Hi-Fi Audio	Quick Service Manual		Ref. No.: HA-99-219
			Date: 10. May. 1999
	Model: SL-PD667 Series/SL-PD10 SL-PD788, SL-PD888	Frequency: C	Cases reported (country) USA

Subject: The Tray Problem

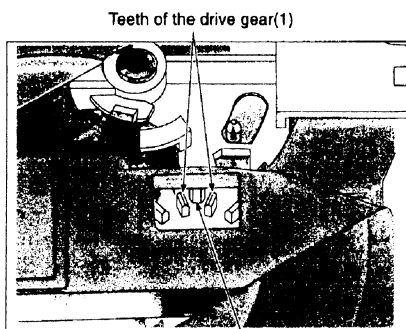
Symptom: The abnormal sound occurs when Tray opens and shuts, or Tray doesn't close.

Cause: It will be occur due to one tooth of the Drive Gear(1):RDG0271(Ref.No.102) is shifted.

Remedy: Please make sure the positioning between the limiter claw on the tray ass'y and the teeth of the drive gear(1) as below.
<Reinstallation of the tray ass'y>

1. Fit the claws on the right side of the tray ass'y underneath the claws on the tray base guide(R).

2. Fit the claws on the right side of the tray ass'y underneath the claws on the tray base guide(L).
